**RESPONSE TO COMMENTS ON
NON-TIME CRITICAL REMOVAL ACTION
90% PHASE I (ONLY) CAUSEWAY DESIGN
STRATFORD ARMY ENGINE PLANT
STRATFORD, CONNECTICUT**

**U.S. ARMY CORPS OF ENGINEERS
NEW ENGLAND DISTRICT
CONCORD, MASSACHUSETTS**

**HARDING ESE, INC.
A MACTEC COMPANY
PORTLAND, MAINE**

August 13, 2001

Figure 1
Causeway Construction
Soil Excavation Locations

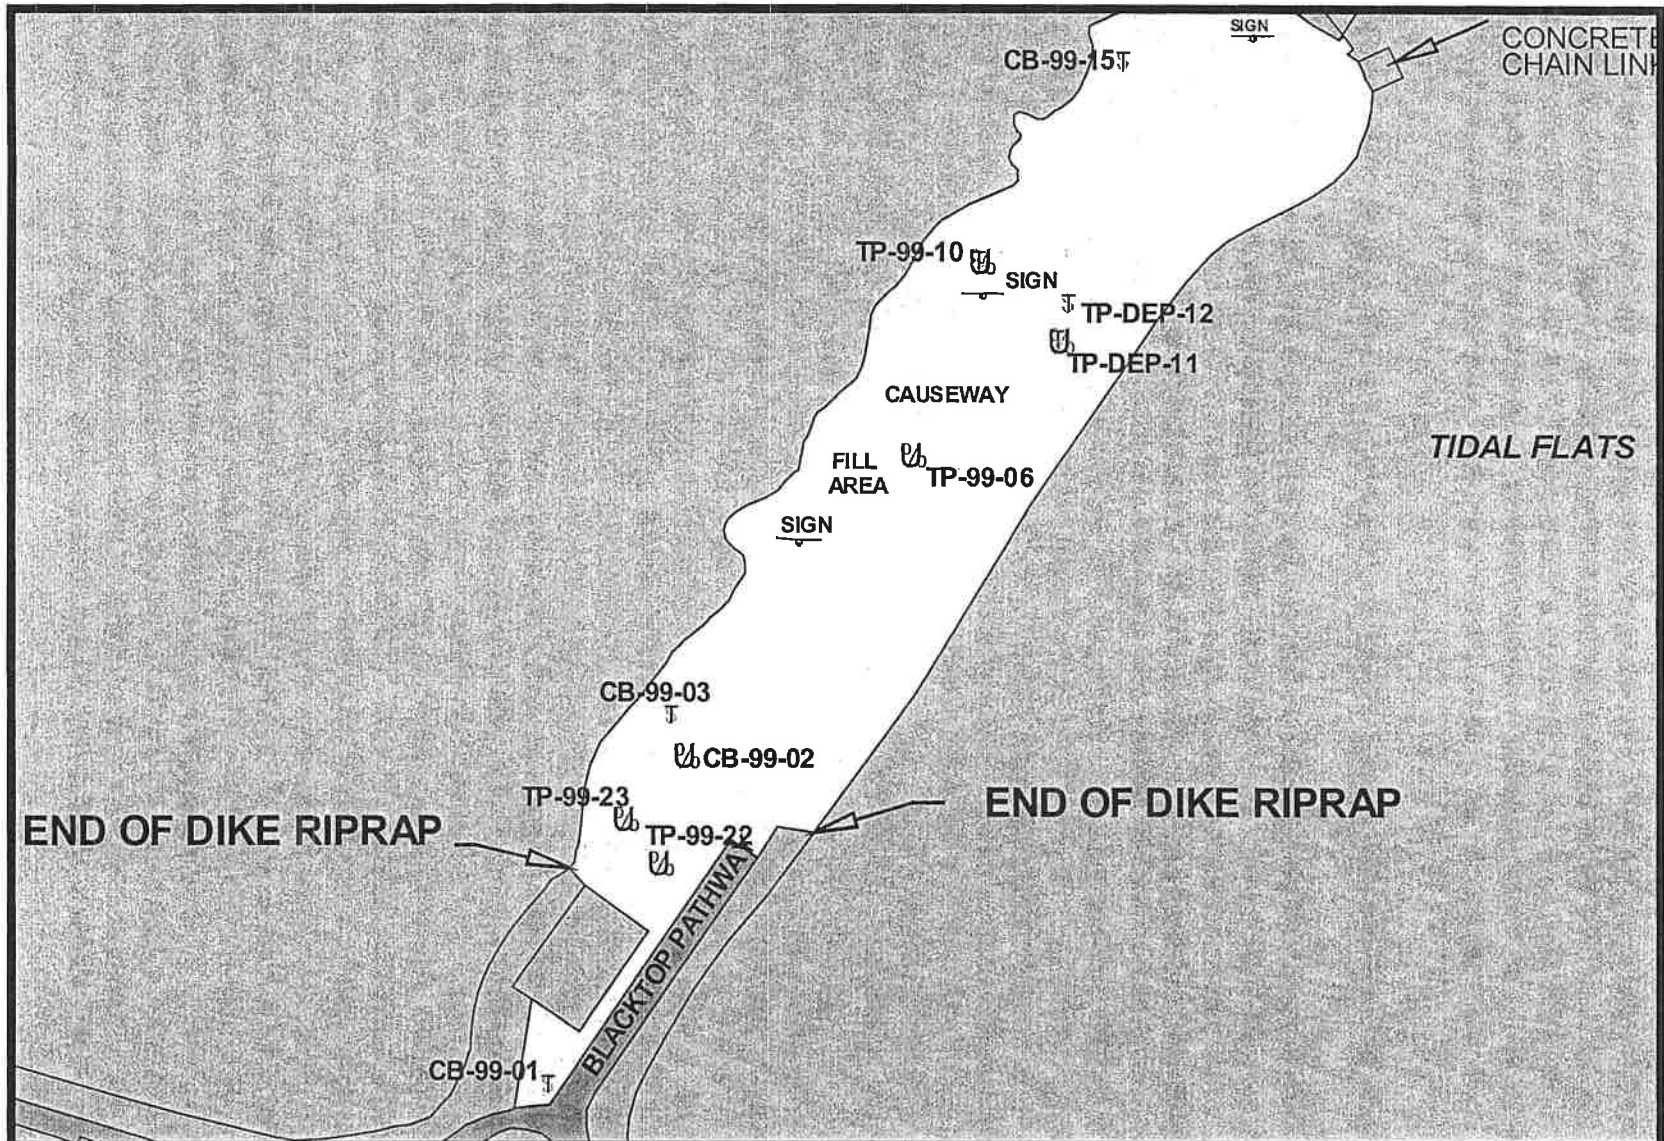
3. Comment: The Army should include spot removal of soil where PCBs greater than 1 ppm have been identified.

Response: There are six locations on the Causeway where PCB concentrations in soil

exceed 1 ppm: TP-DEP-11, TP-99-06, TP-99-10, TP-99-22, TP-99-23, and CB-99-02 (see Figure 1, attached). Total PCB concentrations in soils at these locations range from 1.6 to 11 ppm. Two of the locations (TP-DEP-11 and TP-99-10) where PCBs in soil exceed 1 ppm, are co-located with proposed excavation areas (EA-3 and EA-5) previously identified in the Causeway Design. The remaining four locations where PCB concentrations exceed 1 ppm will be added to areas requiring excavation in the Design, and will be designated as follows:

- EA-7, centered on TP-99-06 (minimum excavation depth 8 feet)
- EA-8, centered on TP-99-22 (minimum excavation depth 3 feet)
- EA-9, centered on TP-99-23 (minimum excavation depth 3 feet)
- EA-10, centered on CB-99-02 (minimum excavation depth 2 feet)
